EDMS NO.
2962891

REFERENCE
LHC-LJ-EC-0054

ENGINEERING CHANGE REQUEST

Installation of the TWOCRIST Goniometers and Roman pot stations during YETS 24-25

Figure 1 — TCCS Goniometer drawing. The tank containing the crystal is visible on the right hand side. Drawing ID ST172900.

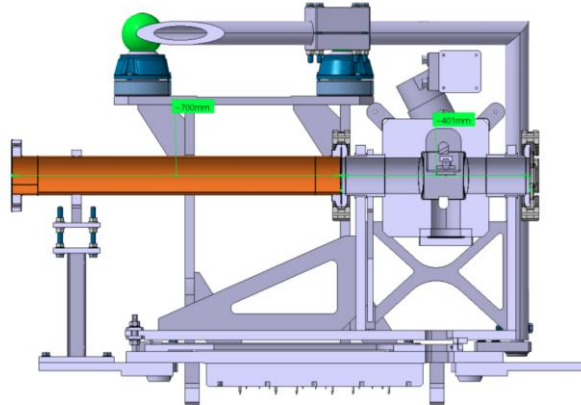
- A high-precision goniometer with a 50 μ rad crystal (TCCS), see Figure 1 showing the goniometer and Figure 2 showing the TCCS crystal. The goniometer was recovered from IR7 (former TCPCV.A6L7.B1, ST1727900), where it was used for crystal-based collimation in the vertical beam plane [3]. In a physics experiment, the crystal is needed to split off beam halo particles to a large amplitude onto a target. A very exact angular alignment is needed: the high-precision goniometer used for the TCCS provides an angular control below 1 μ rad and a linear step size of 5 μ rad. The design of the goniometer is such that a replacement chamber can be used to surround the circulating beam in high intensity operation, to avoid impedance related beam instabilities or undesired heating. The position (DCUM)

of the device was specified based on beam dynamics simulations to be ideally in the range 6775 ± 2 . The TCCS will be installed from DCUM 6773.72 to 6774.12 [4].

Figure 3 — TCCP assembly with target and TCCP crystal in the tank. Two RF bands were added to seal the gap between the inner beam pipe and the outer one, to reduce the impedance of the device. Drawing ID ST1756862.

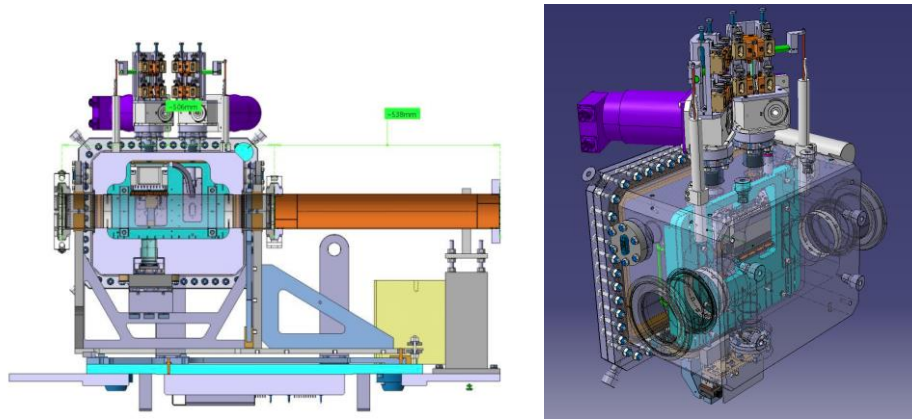
- A new high-precision goniometer holding the long TCCP crystal (7cm) with strong deflection (7mrad) with a movable integrated target (**TCCP**). The assembly was designed specifically for TWOCRIST (ID LHCTCCP_0003). It is designed to provide independent vertical linear motion of the TCCP crystal (see right hand side of Figure 2) and of a tungsten target 200 μ m upstream of the crystal. Additionally, it provides an angular precision of 1 μ rad for the alignment of the TCCP crystal. At the time of writing, the TCCP assembly is being constructed. The TCCP assembly is shown in Figure 3. The position (DCUM) of the device was specified based on beam dynamics simulations to be ideally in the range 6655 ± 2 . The TCCP will eventually be installed from DCUM 6653.04 to 6653.55 [4]. Crystals and goniometer were designed and were/will be built based on the functional specifications defined by the BE-OP, BE-ABP and SY-STI [5].

Figure 4 — Shared secondary vacuum system of the Roman Pot stations [8].

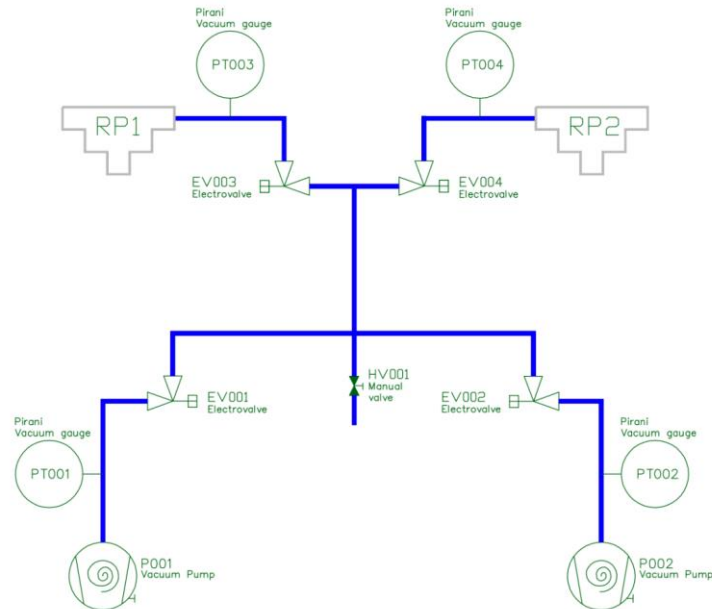
- To approach the detectors, close to the LHC beam, the Roman Pot is thinned down to about 200 μm in the dimension between the detector and the beam. This part is called the thin window. This feature is not strictly needed for the IR3 setup but was retained to minimize the new hardware to be built. To keep the thin window from bending, a secondary vacuum needs to be applied to the

detector volume. Since the bending of the thin window depends on pressure difference, the secondary vacuum pressure requirement is moderate: Some 10s of mBar. The design of the secondary vacuum system is illustrated in Figure 4 and described in detail in [8]. It will be based on two rotary vane pumps, which are frequently used in similar environments at CERN.

Figure 5 — Differential layout in vacuum sector A5R3, EDMS **3118297**, CERN CDD [LHCLJ 3U0048](#), Smarteam **ST1783887_2**.

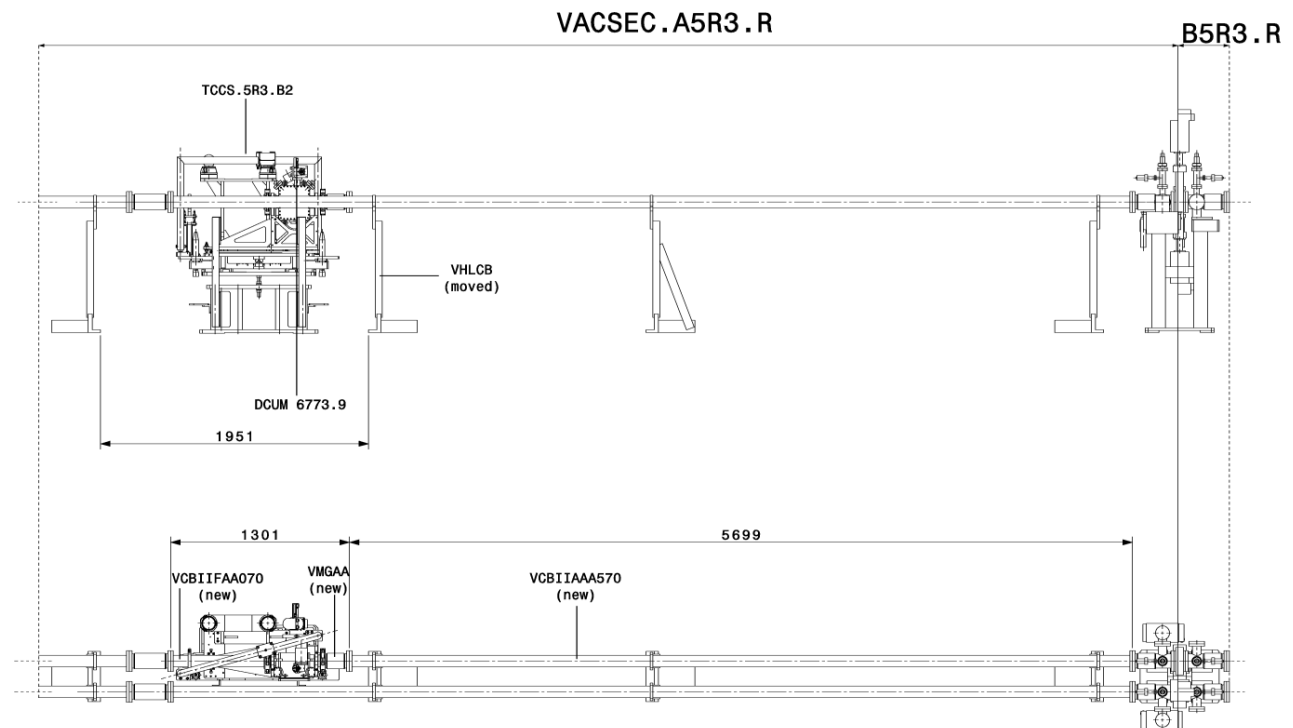
The differential layout for vacuum sector A5R3 is shown in Figure 5.

Figure 6 - Differential layout, EDMS **3105243**, CERN CDD [LHCLJ 3U0047](#), Smarteam **ST1783800_02**

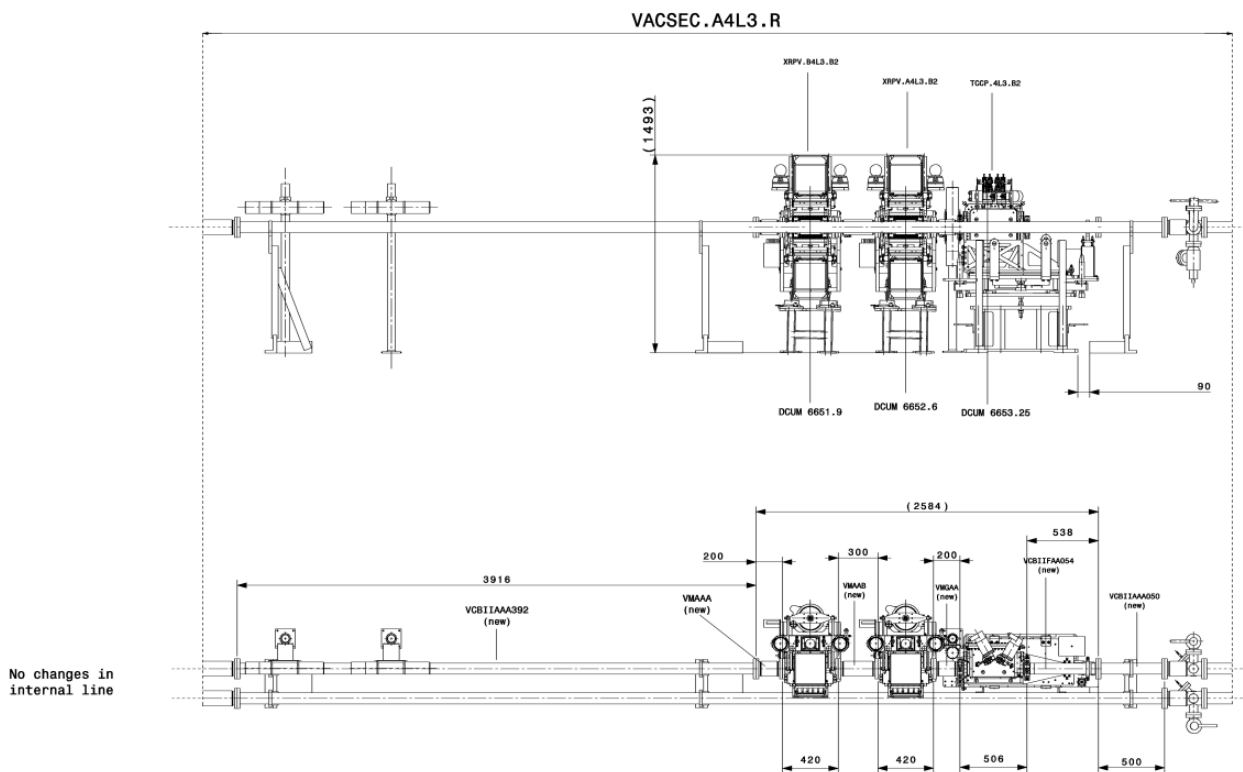
The differential layout for vacuum sector A4L3 is shown in Figure 6.
